RESPONSE TO COMMENTS  
AND FINAL PERMIT DECISION

OPDES Permit Number: OKS000101 City of Oklahoma City Municipal Separate Storm Sewer System (MS4) Permit

Date Prepared: December 29, 2023

Permit Action: Response to comments received on the proposed permit publicly noticed on October 20, 2023, by DEQ, and by the City of Oklahoma City on October 24, 2023; and final permit decision to reissue OPDES Permit No. OKS000201.

Item 1: Table I-1 Existing Approved TMDLs Affected by Permittee(s)’ Stormwater Discharges (page 12)

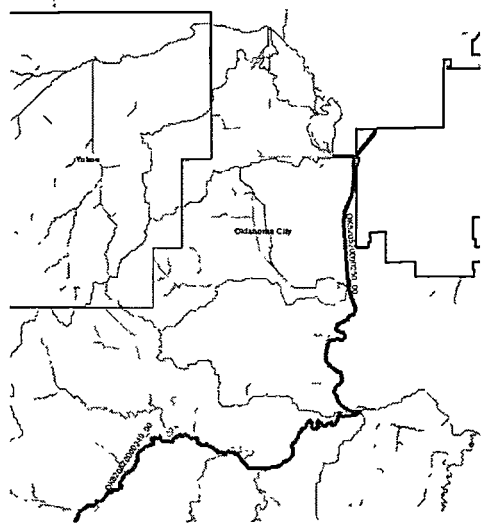
Item 1 Comment: Regarding water body identification (WBID) segment OK520520000250\_00, North Canadian River, highlighted in Table I-1 of the draft permit (see highlighted in table above). The stream segment has a load reduction identified for fecal coliform but not for Escherichia coli (*E. coli*) or enterococcus (see Table ES-3 of the Bacteria Total Maximum Daily Load (TMDL) for North Canadian River Area (OK520520)).

Fecal coliform standards are no longer part of the Primary Body Contact Recreation (PBCR) water quality standard(s) and beneficial use assessment protocol. The segment (as provided in the TMDL) also lacks additional *E. coli* and enterococcus data supporting a Total Maximum Daily Load (TMDL) assignment/reduction for those parameters.

Question 1: Without a supported water quality standard for fecal coliform and since a TMDL was not developed for *E. coli* or enterococci, is it appropriate to assign a bacteria reduction requirement based on a historical standard which is now obsolete?

With regard to Question 1 as to whether it is appropriate to assign a bacteria reduction requirement based on a historical water quality standard (WQS) for fecal coliform which is now obsolete (replaced by WQS for *E. coli* or enterococcus), DEQ has consulted with EPA. EPA has directed that these fecal coliform Total Maximum Daily Loads (TMDLs) and associated Wasteload Allocations (WLAs) and required percent reductions remain in effect and the required percent reductions should be applied to *E. coli* or enterococcus until such time as new TMDLs for *E. coli* and/or enterococcus are approved or established. The final permit has been revised to add a footnote to Table I-1 to clarify this requirement. DEQ notes that this requirement also applies to stream segment OK52052000070\_00 (Crutcho Creek), for which the TMDL also established required percent reductions for fecal coliform, but not for *E. coli* or enterococcus.
